ACTION TRANSMITTAL – 2019-08

SUBJECT: Draft Amendment to the 2040 Transportation Policy Plan to amend METRO Gold Line project and amend I-94 project from MN 101 to I-494

2040 Transportation Policy Plan Amendment #2

Figure 1: Project Area and Major Elements

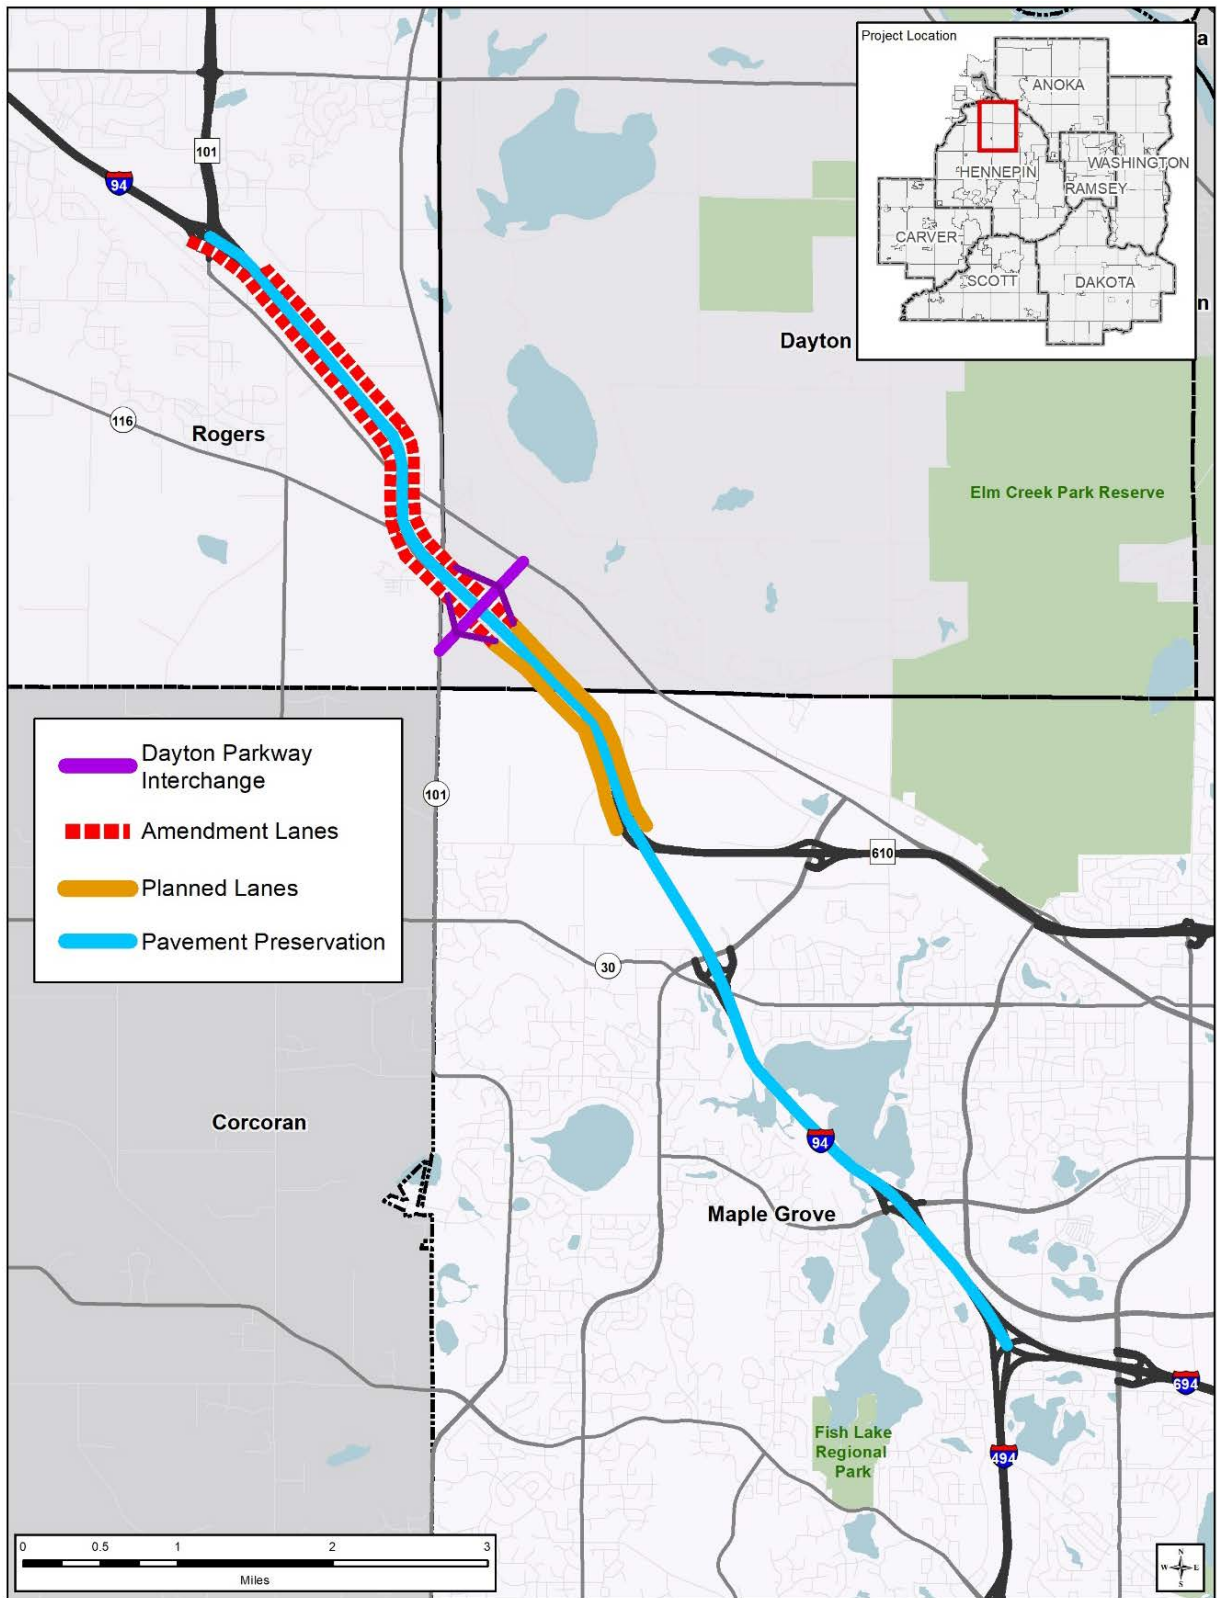
The following project description and map for the work along I-94 reflects the extension of the proposed lanes along I-94.

Added lanes along I-94 from TH 610 to TH 101 Located in Northwest Hennepin County, this corridor connects the Twin Cities metropolitan area to Greater Minnesota. It serves as both a major freight and recreational corridor for the state. The project includes long term pavement preservation between I-494 and TH 101 and added lanes, between TH 610 and TH 101 (see Figure 1). The project is anticipated to begin construction before the end of 2019.
